WATTS BAR NUCLEAR PLANT (WBN) UNIT 1 - RESPONSE TO NRC QUESTIONS ON TVA'S
QA RECORDS CORRECTIVE ACTION PROGRAM (CAP) PLAN, REVISION 4

RESPONSE TO NRC QUESTIONS OF JANUARY 30, 1992

CONCERNING TVA'S QUALITY ASSURANCE RECORDS CAP (REVISION 4)

PRIMARY DEFICIENCY FRACTION FOR ANSI TYPE C10

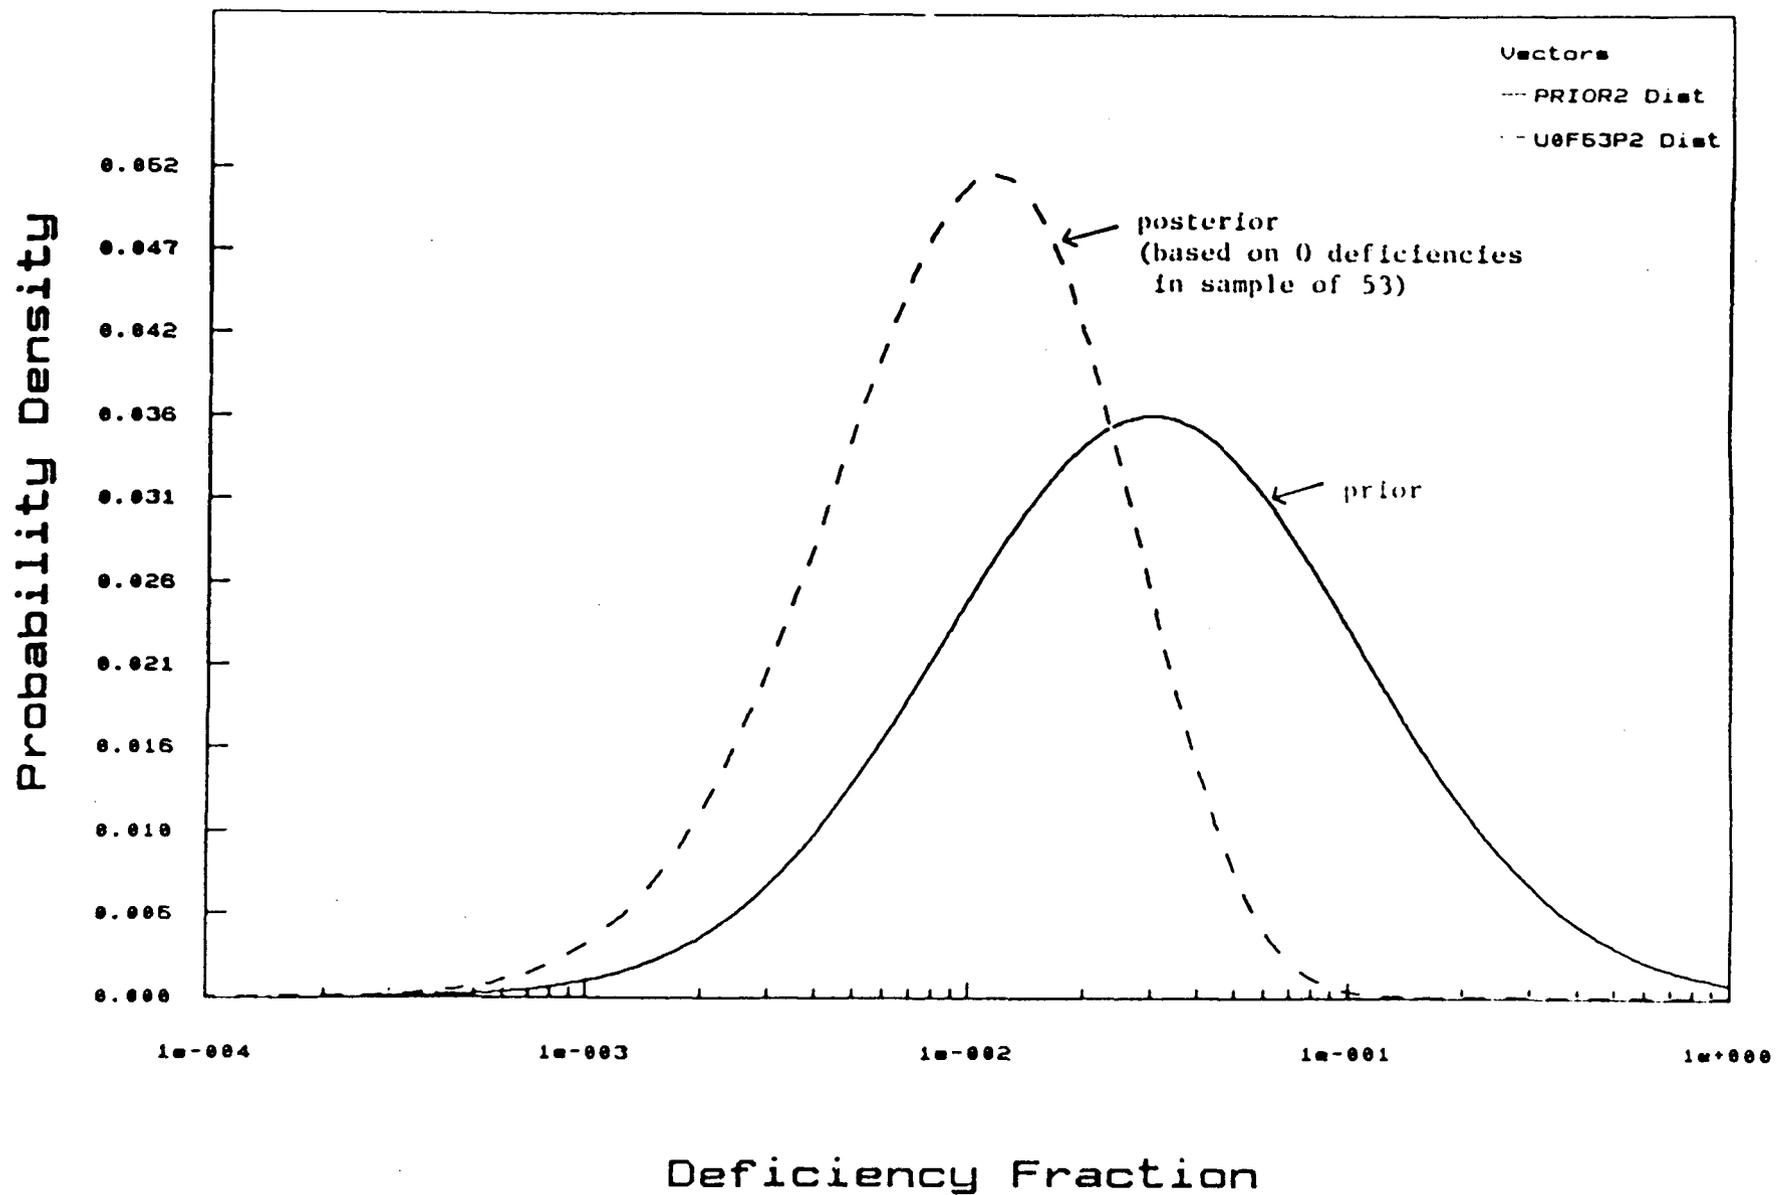
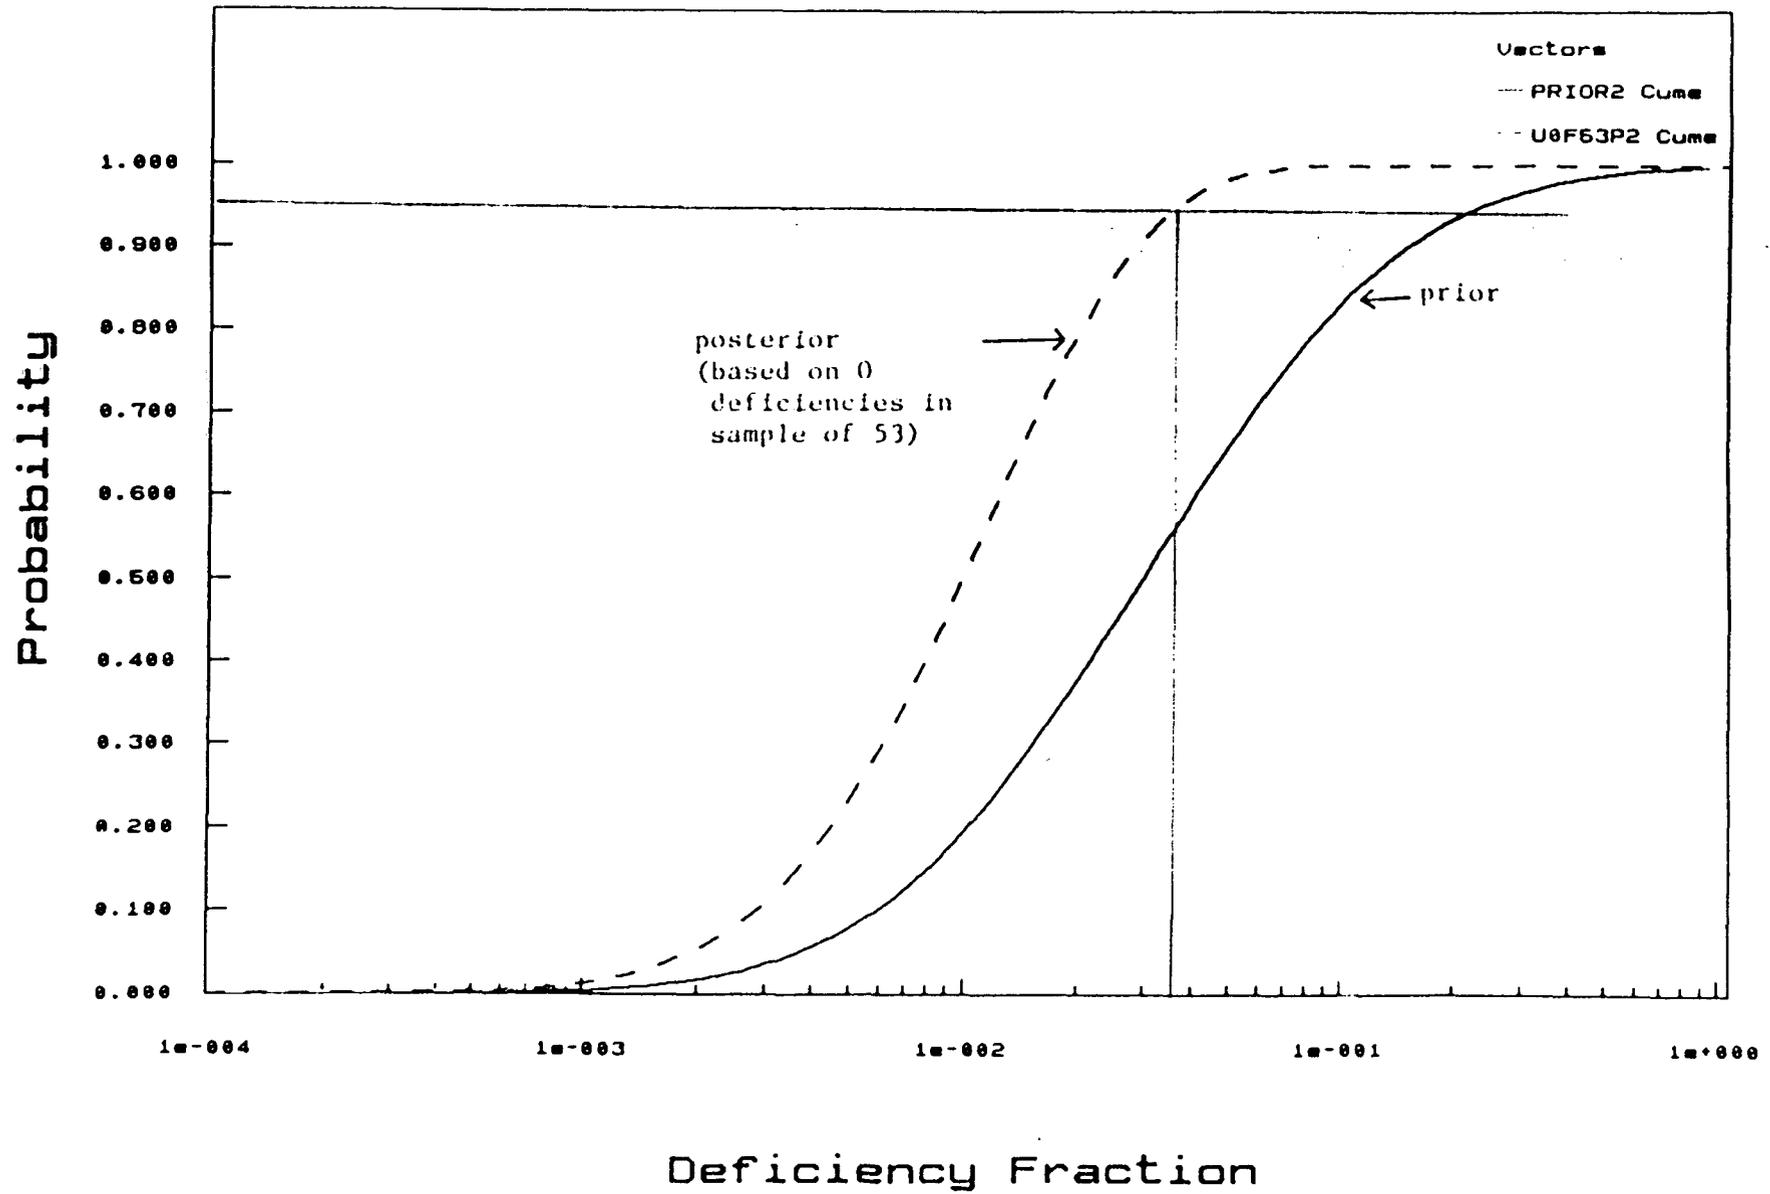
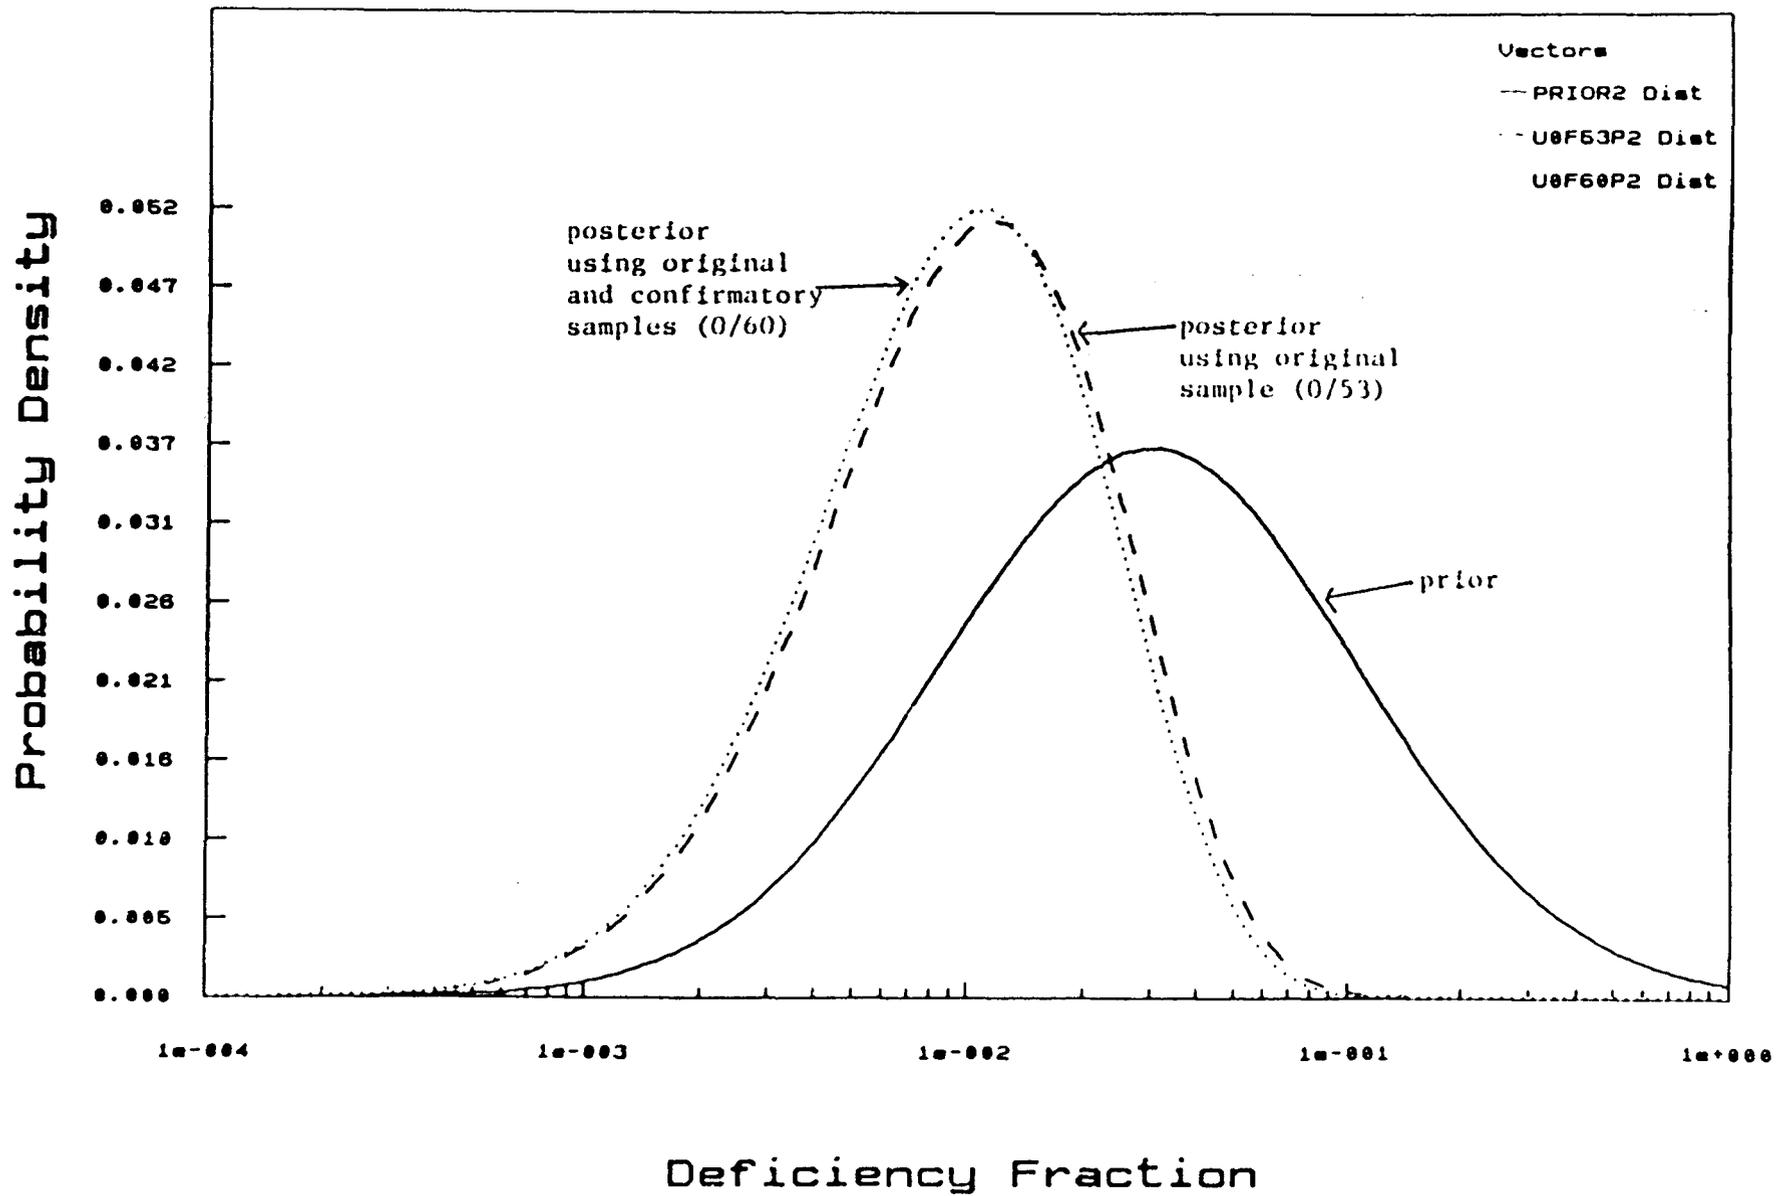
Whether using the sampling plan and acceptance criteria proposed in the ASRR or using a standard classical approach, the question arises as to what happens if the acceptance criterion is not met. We understand that the "extent of condition" will be determined and followed-up to reduce the probability of finding another deficiency in the same cell when the next sample is randomly selected. Clarify whether another random (though "stratified") sample will be tested for the new, improved, population.

This evidence is used in Figure 1 to update our prior state of knowledge (represented by the curve PRIOR2) about the deficiency rate in ANSI C10.

Figure 2 shows the same results in cumulative form. From this figure we observe that we have 95% confidence that the deficiency fraction is less than 4%. We could conclude, therefore, on the basis of the original sample, that this ANSI group passes our acceptability criterion for primary deficiencies.

In addition to this, however, we now have the evidence of the confirmatory sample of size 7. Updating figures 1 and 2 with this additional evidence we obtain figures 3 and 4 showing 95% confidence that the primary deficiency fraction is less than 3.5%, based on both the original and confirmatory samples.
